REMARKS

This is a full and timely response to the outstanding Action mailed September 20, 2005. Upon entry of the amendments in this response, claims 1-14 remain pending. In particular, Applicant has amended claims 1, 5, and 10 and has cancelled claims 2-3 and 7-9 without waiver, disclaimer, or prejudice to the subject matter contained therein.

FIG. 7

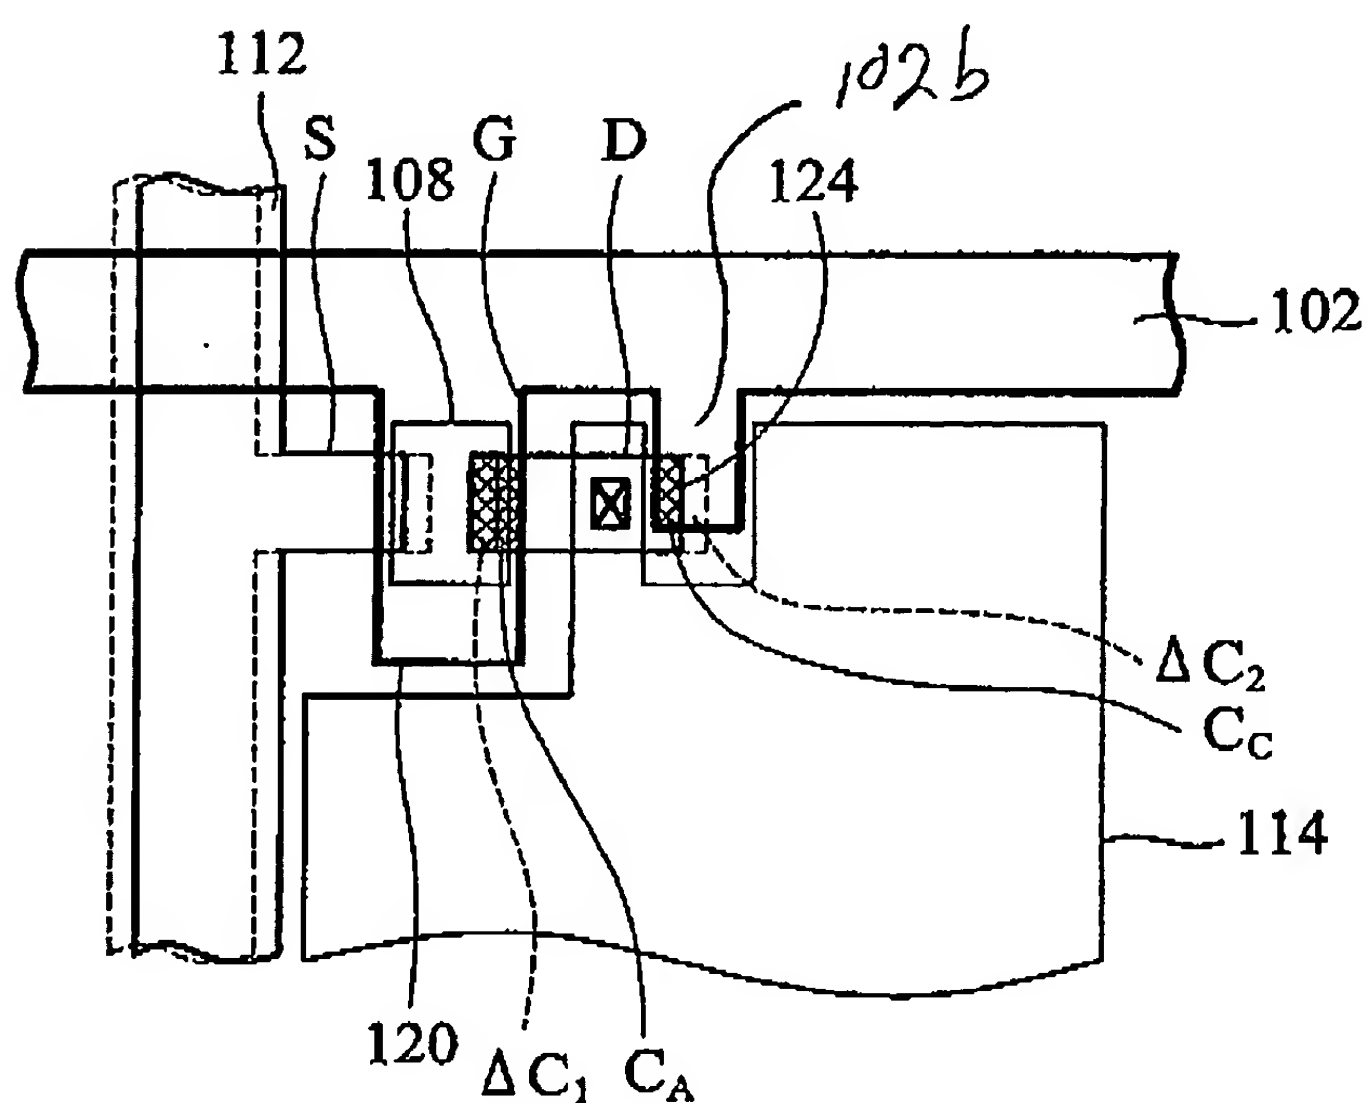
Please amend Fig. 7 (adding a label "102b") as show in the accompanying drawing sheets.
